TELEDYNE CONTINENTAL® AIRCRAFT ENGINE **SERVICE BULLETIN**

SB97-5

SUBJECT: INSTALLATION OF FLANGED TYPE FRONT MAIN BEARINGS

AFFECTED: O-470 and IO-470 engines utilizing 537401, 646807 or 538879 standard or oversize one

FIGURE 2. THRUST SURFACES

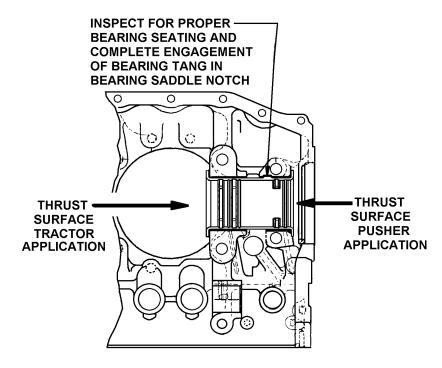
When installing any bearing insure that the bearing saddle and bearing back are clean, free of any oil and that no debris will be trapped between the bearing back and bearing saddle. Flanged front main bearings must be positioned in the bearing saddle so that the thrust flange is firmly seated against the machined thrust surface of the bearing saddle.

The thrust surface is the surface that absorbs the load of the crankshaft during engine operation. Figure 2.
